Community Meeting Comments:

A.B. ERNST PARK

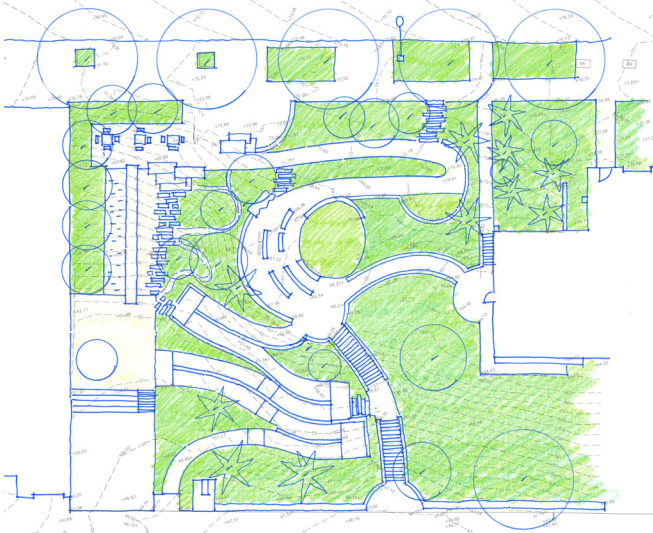
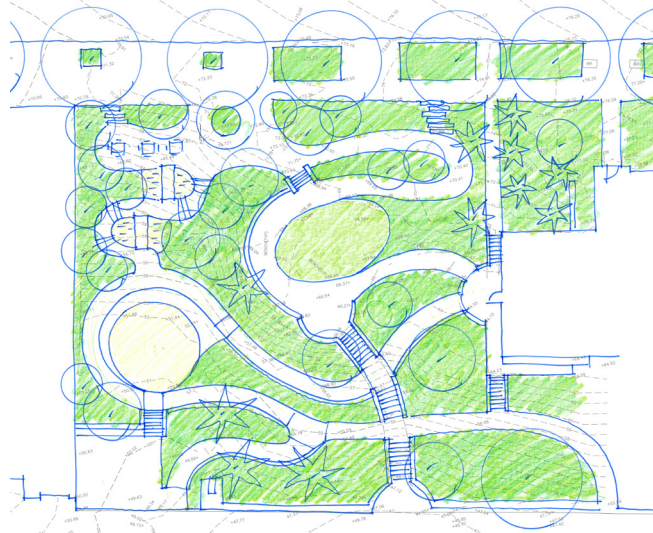
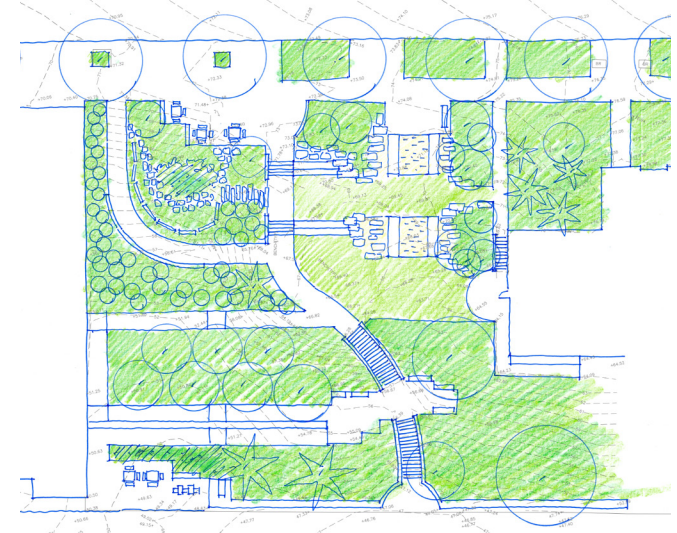
- Incredible waste that did not get ADA access right the first time. Why do we need ADA access from the alley? Is someone asking for that?
- Activating with play is important. No basketball courts, too loud.
- Need comfortable seating/places for people to read that is an extension of the library. Seats with backs.
- Weddings have been held at Ernst Park. Design for events that flow in and out of library meeting room.
- Keep the idea of amphitheater type/oriented seating.
- No seating by alley/BMX shop. Dark hole down there with poor visibility from above.
- Too much paving, too much impervious.
- Library doesn't use gathering area for story time because it needs to be reserved and rented (with fee) from the Parks Department.
- Art features that relate to the library - book themed.
- Change name of park to "Fremont Library Park". Nobody knows or cares about A.B. Ernst.

- Community fought for the park.
- Kid comments - want a playground and swings. Like giant slide.
- Swings could be like porch swings, not just for kids and need less room for fall zone.
- Would like a p-patch. Long waiting lists at other ones in the area.
- Use plants that are drought tolerant - lavender, rosemary.
- No skateboard facilities - they don't share and will take over.
- Enhance the library.
- Please revisit wheelchair access.
- Activation up by street has nicer access.
- Like A-2 the best due to sinuous cohesive pathways, but so much pavement.
- B - ADA access start needs to be closer to the library.
- Court as maintenance access is important, for library too.
- Rock climbing wall?
- Honor the open space for the adjacent landowner.
- Call it Fremont Central Park.
